ENGINE - FUEL AND CONTROL - ENGINE FUEL AND CONTROL - FUEL METERING UNIT (FMU) -  
INTRODUCTION OF REVISED FMU WITH OSV AND PRSOV PUSH-RODS COATED WITH TUNGSTEN CARBIDE  
- LUCAS AEROSPACE SB FMU 530-73-8061 - CATEGORY CODE 6 - MOD.ENG-73-0123

V2500-ENG-73-0123

NUMBER FMU 540-73-8061

ENGINE - FUEL AND CONTROL - FUEL METERING UNIT - COATING OF THE PUSH ROD WITH  
TUNGSTEN/CHROMIUM CARBIDE SDG 2005

Figure 1

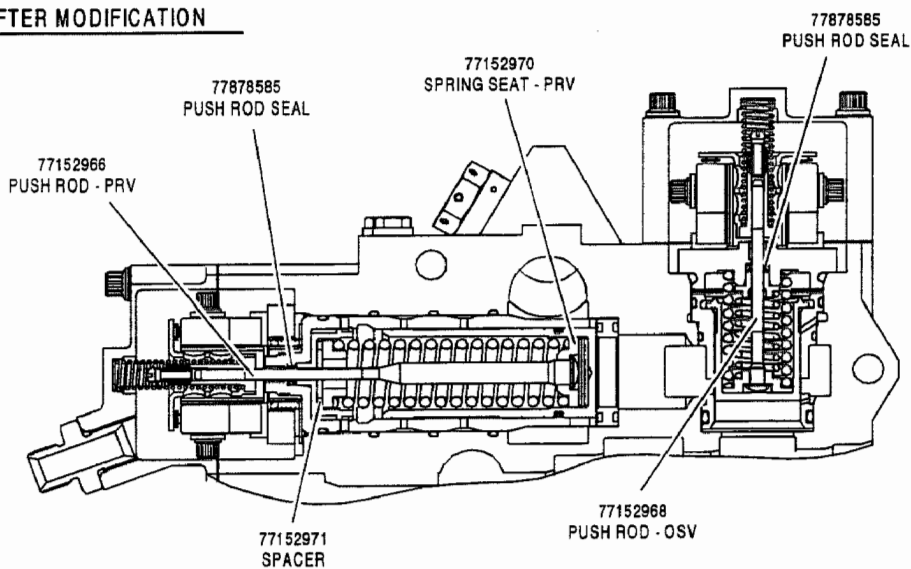
(a) The OSV/PRS0V push-rods have been coated with Tungsten Chromium Carbide. The diameter of the heads of the pushrods has increased.

(b) The PRS0V spring seat has been modified so that the revised PRS0V push-rod can be installed.

(c) To reduce the production of debris, the shim pack under the PRS0V spring seat has been replaced by a steel spacer.

This modification introduces  
Tungsten/Chromium Carbide  
coated push rods to reduce the wear  
rate on the push rod and seals.  
Ground spacers replace the multiple  
shims.

2. Accomplishment Instructions (Refer to Fig 1)

Assemble Post CP8061 modification kit parts to the FMU in accordance with the relevant Component Maintenance Manual (Ref 1. K. References (1)). All checks, setting and testing procedures must be performed.
